ADDENDUM NUMBER ONE
TOWN OF HOT SPRINGS WASTEWATER TREATMENT PLANT UPGRADE
COLLAB_417(A)
MADISON COUNTY, NORTH CAROLINA

This Addendum Number One is issued this the 11th day of September 2025 to all parties who hold a set of Bid Documents for the project entitled: "Wastewater Treatment Plant Upgrade". This Addendum Number One shall become part of the Contract Documents, and its receipt shall be acknowledged on the bid documents at the time of bidding.

WASTEWATER TREATMENT PLANT UPGRADES TOWN OF HOT SPRINGS

PROPOSED SITE PLAN		
DATE	PROJECT #	FUNDING #
SEPTEMBER 2025	23.00328

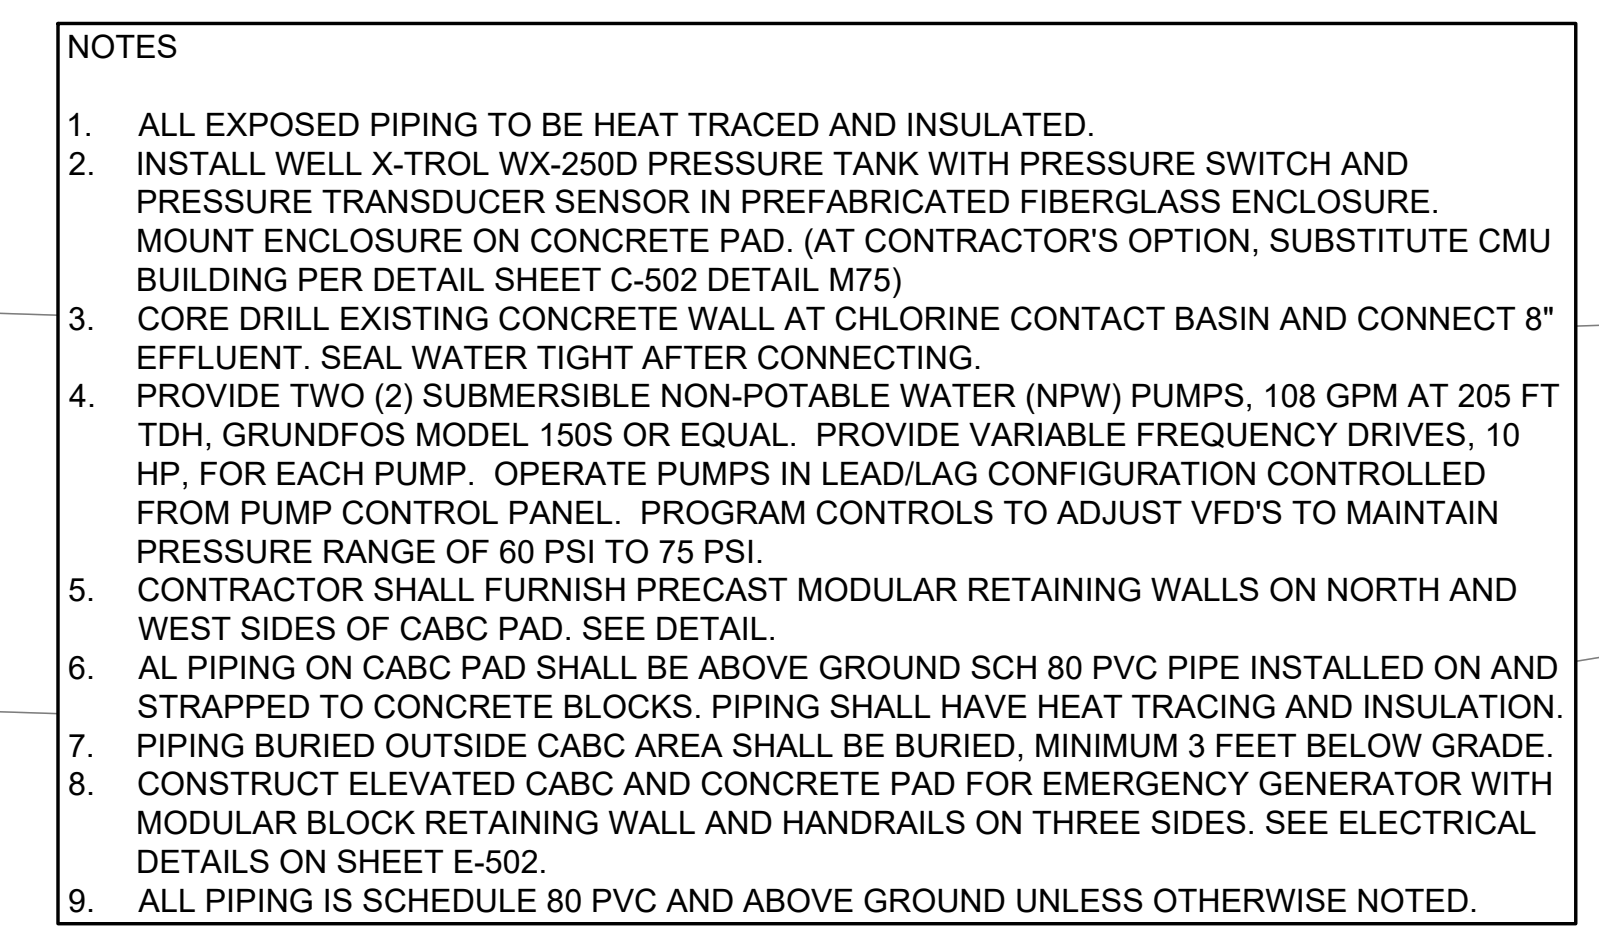
- Removal of original base bid MBR configuration (end to end setup) from the contract. Formerly Alternate site plan MBR configuration (parallel setup) is now considered the base bid.

- Updates to piping layout and underground/above ground configurations. Note that above ground piping is to be heat treated in accordance with *Specification Section 404113 Heat Tracing for Piping*.

NOT TO SCALE		BLOWER DETAILS		
OFFICE MANAGER M. CATHEY	DESIGNER W. HALE	DATE SEPTEMBER 2025	PROJECT # 23.00328	FUNDING #
PROJECT MANAGER K. WEBB	REVIEWER -

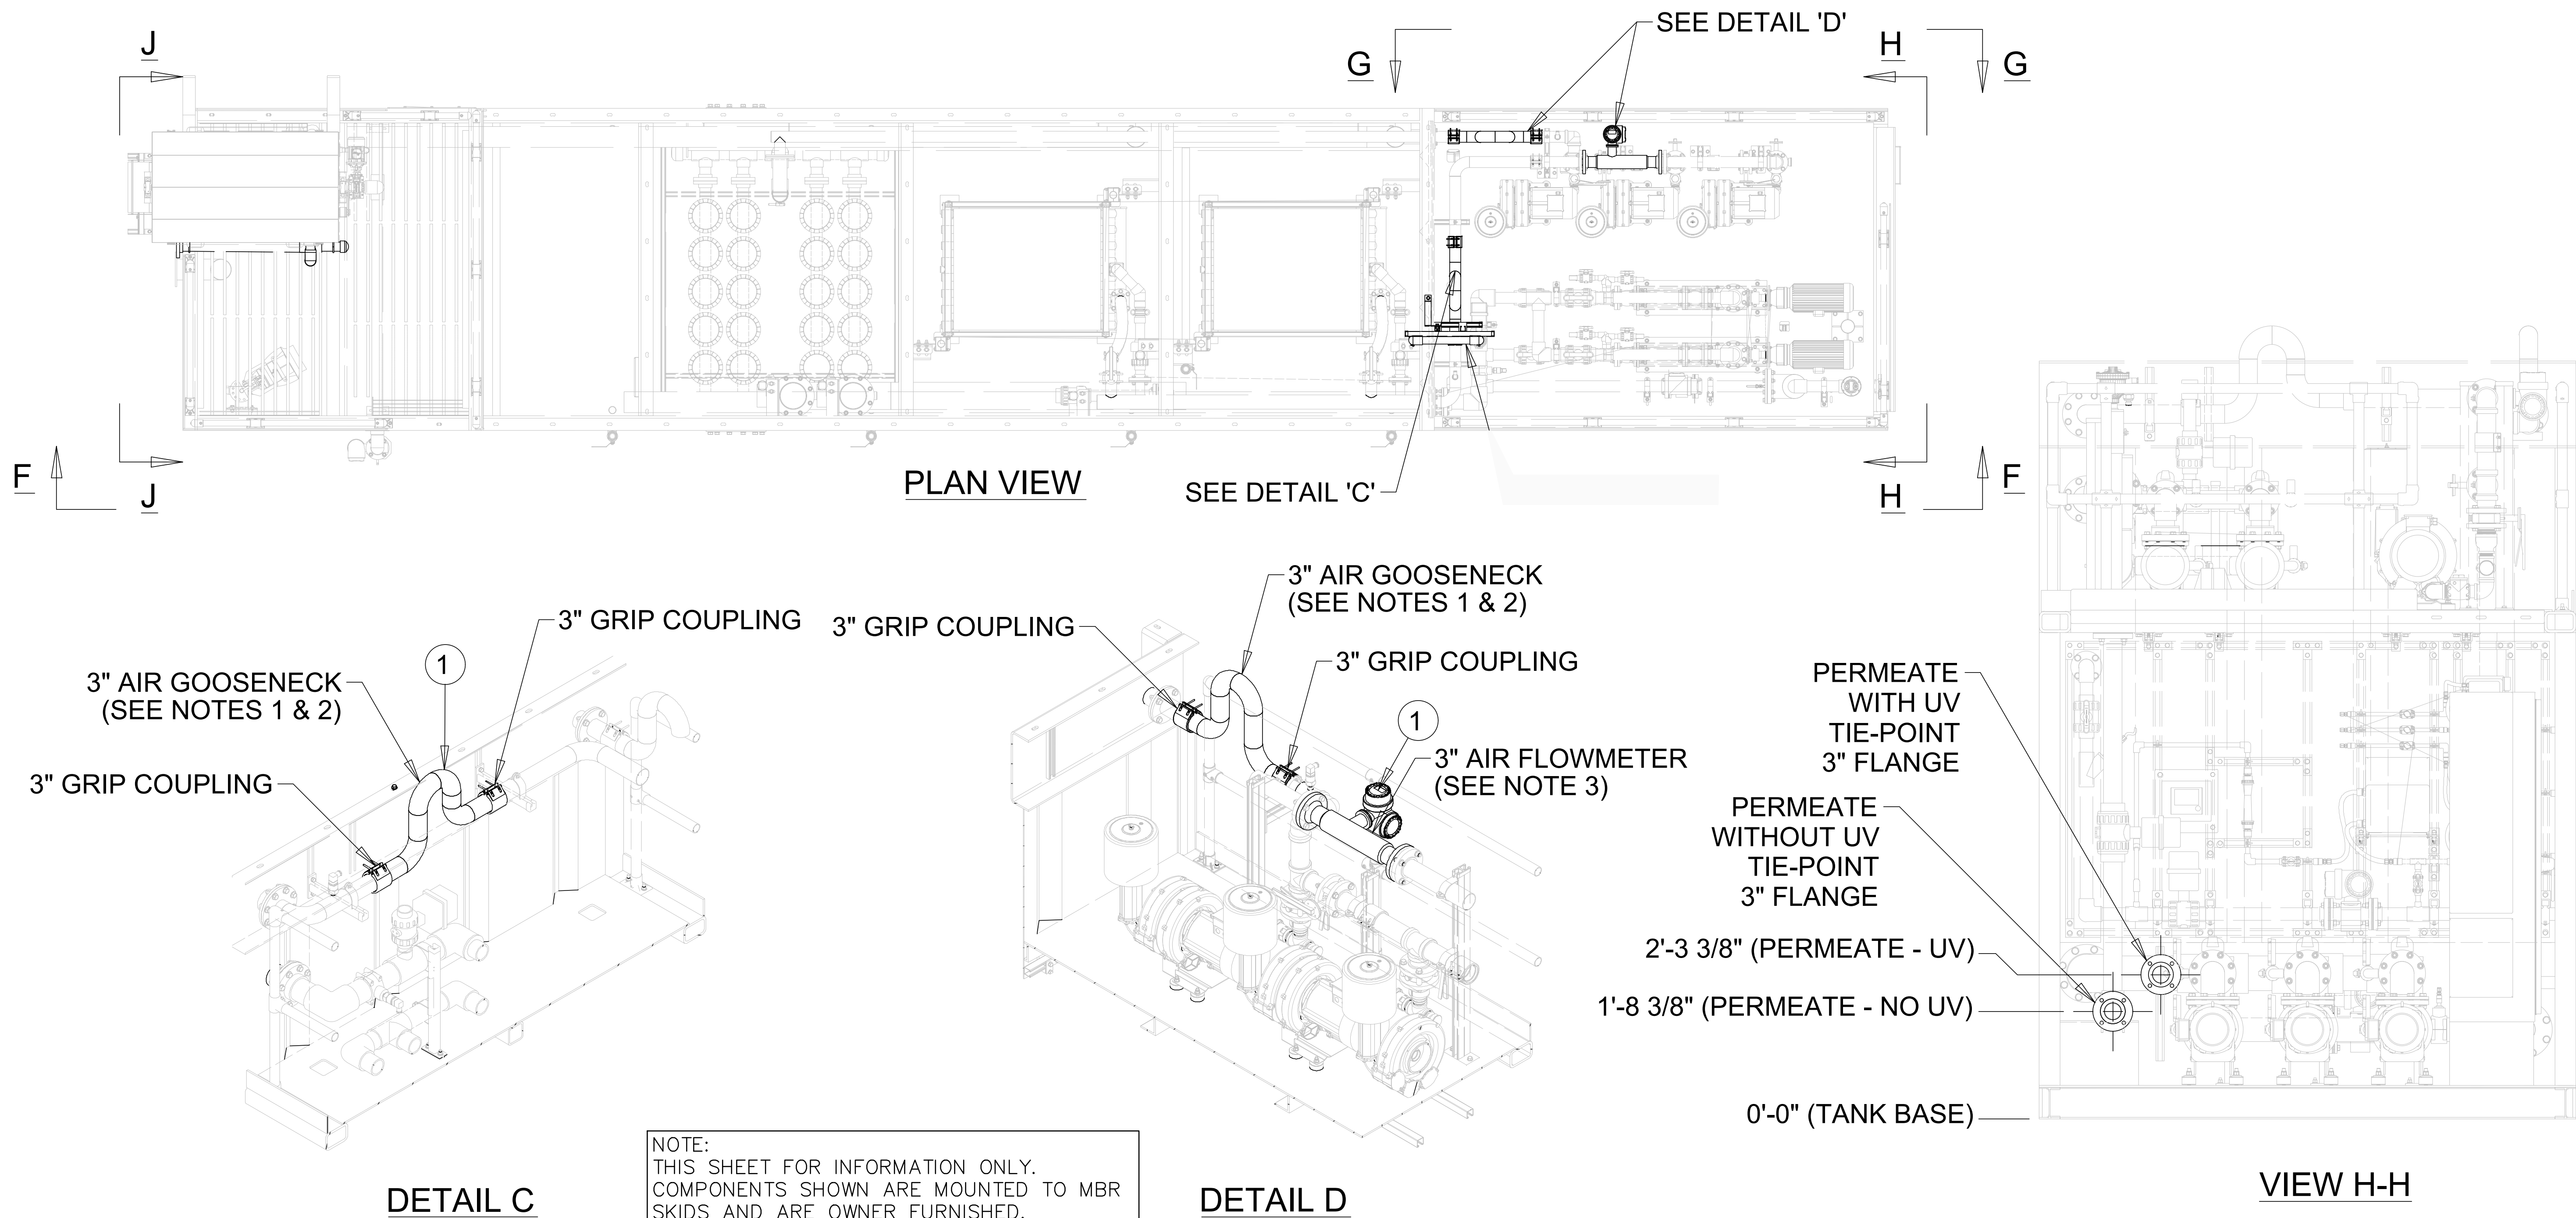
- Clarification that the contractor is responsible for supply and delegated design of stairways and walkway seen on sheet C-103.
- B. Clarification that the stainless-steel pipes and air goosenecks called out on Plan Sheet C-105 Blower Details are a pre-installed component of the Modular MBR Unit that has been repurchased by the town.

PROPOSED WASTEWATER TREATMENT PLANT ELECTRICAL SITE PLAN		
DATE SEPTEMBER 2025	PROJECT # 23.00328	FUNDING # N/A

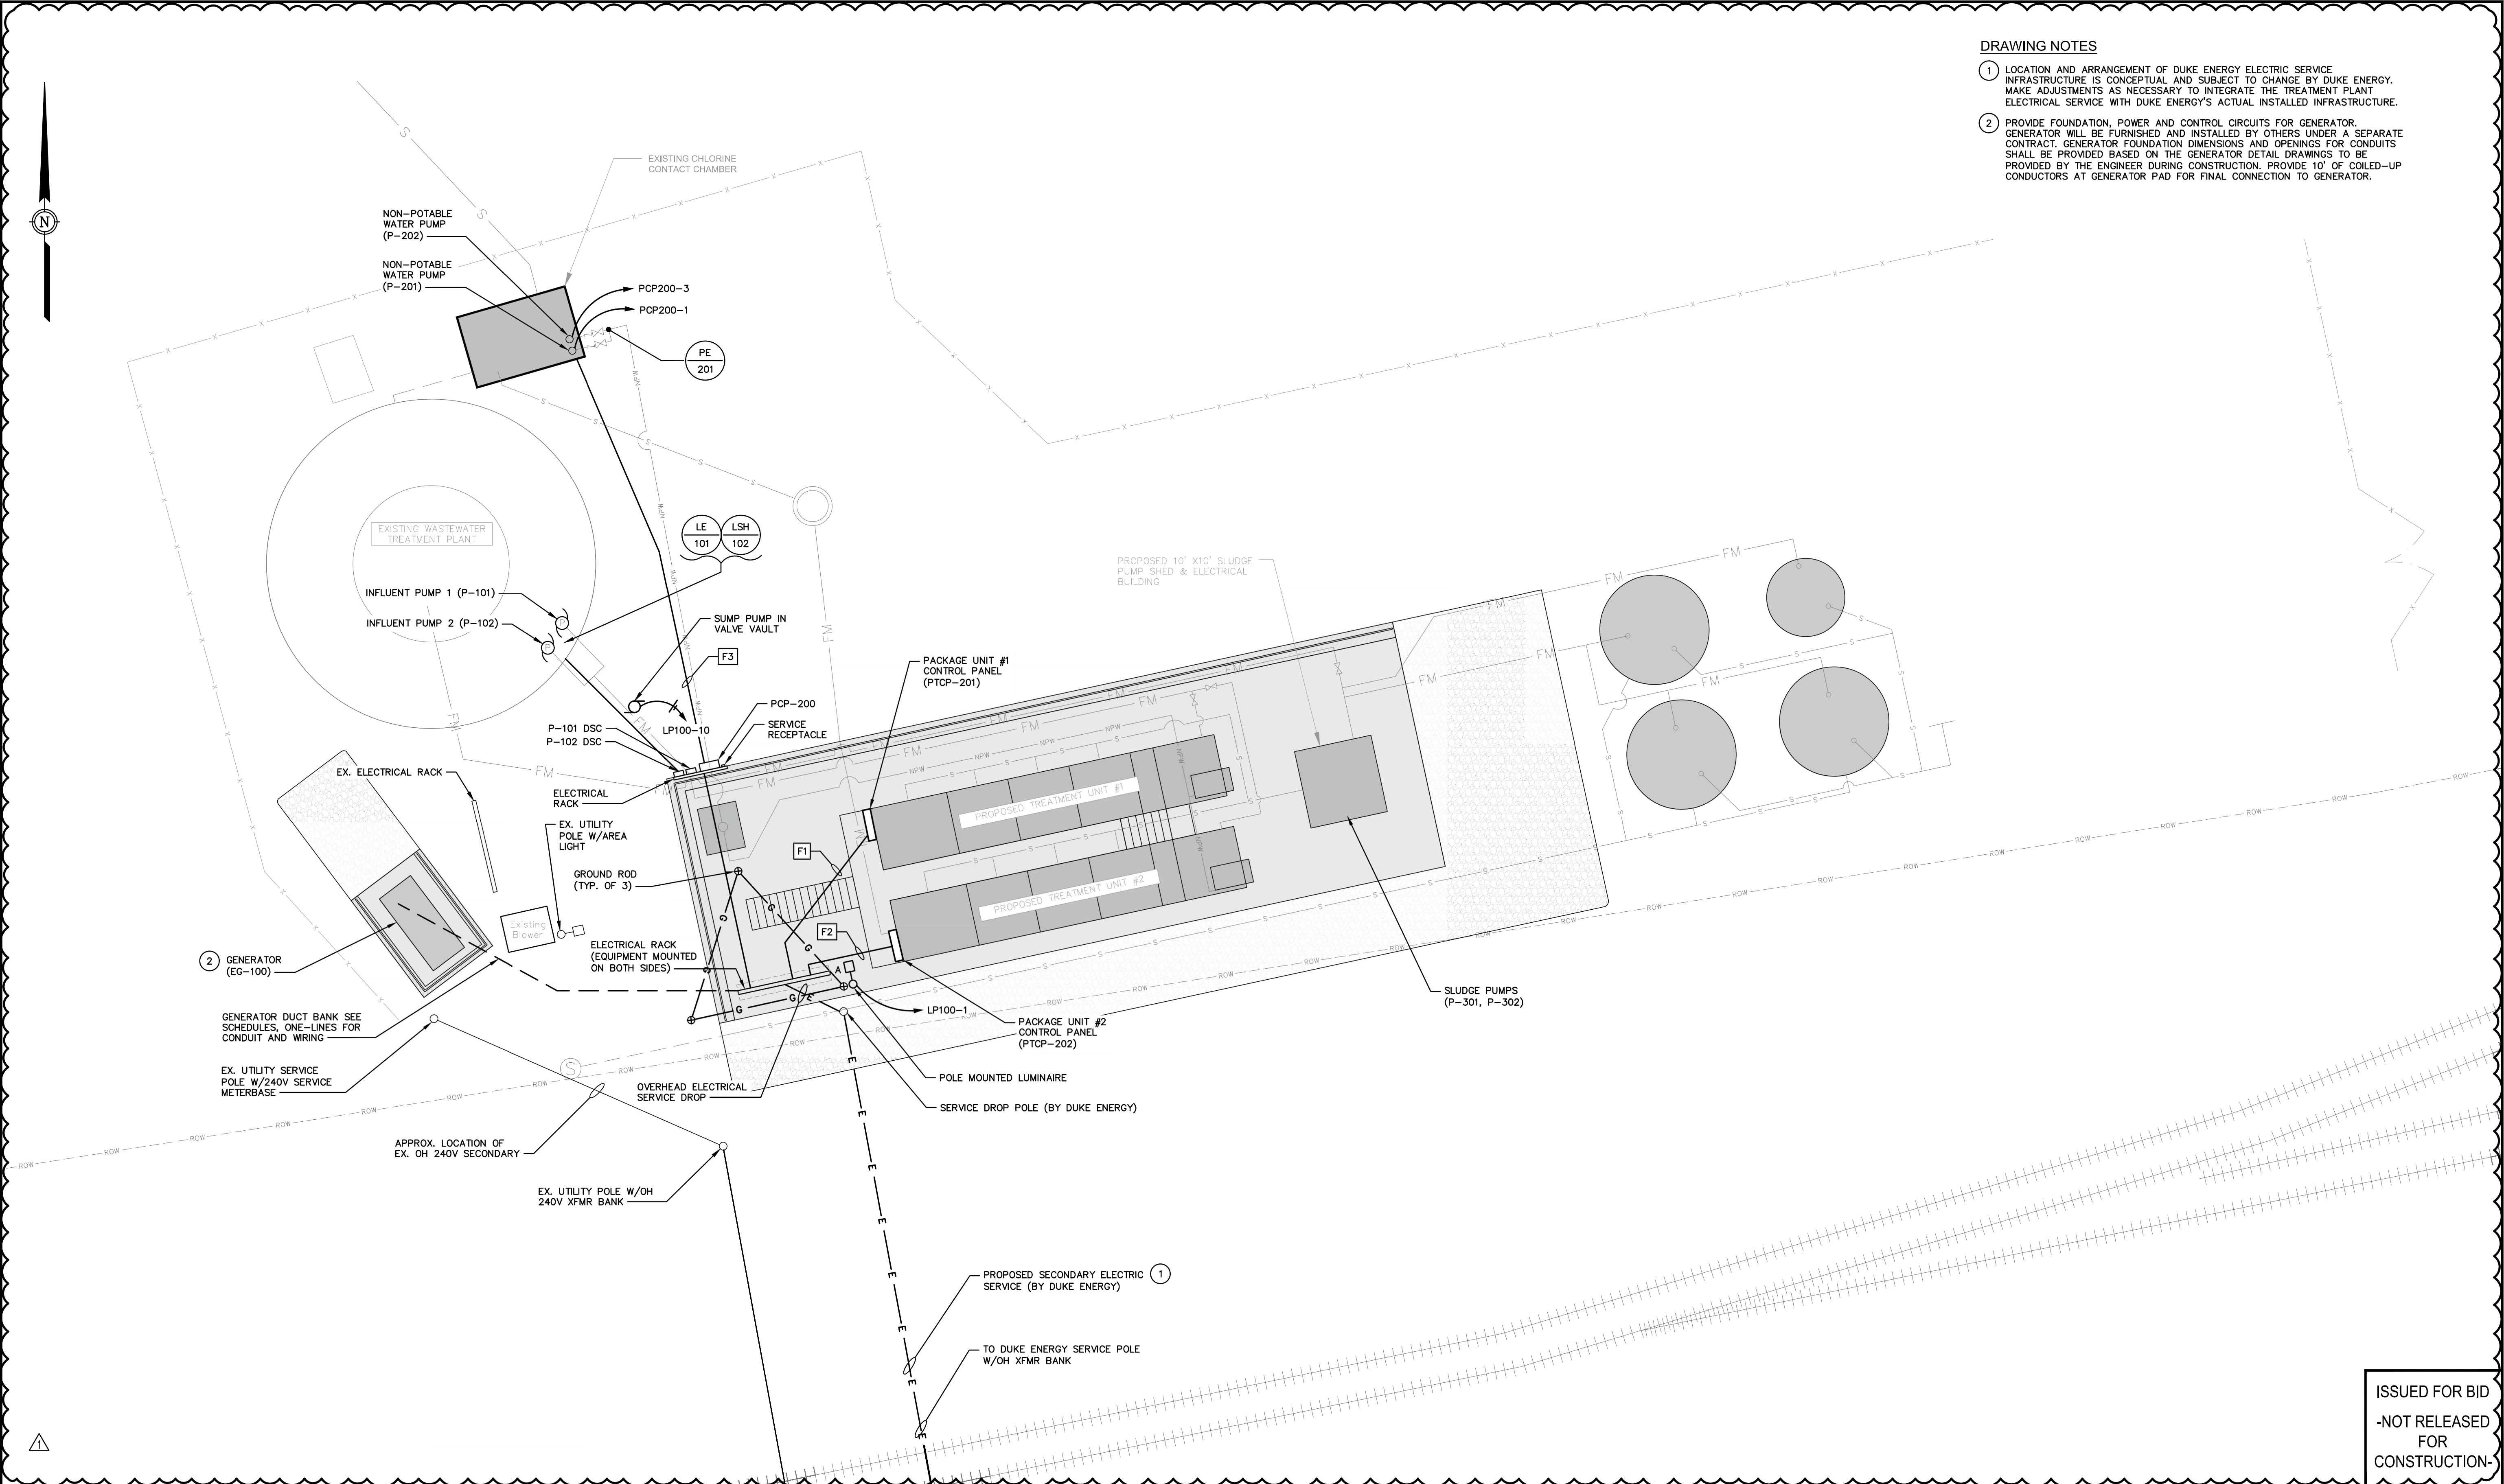
- Relocation of proposed emergency generator from CABC pad to be adjacent with existing electrical equipment. – see attached Electrical sheets E-101 to E-701.
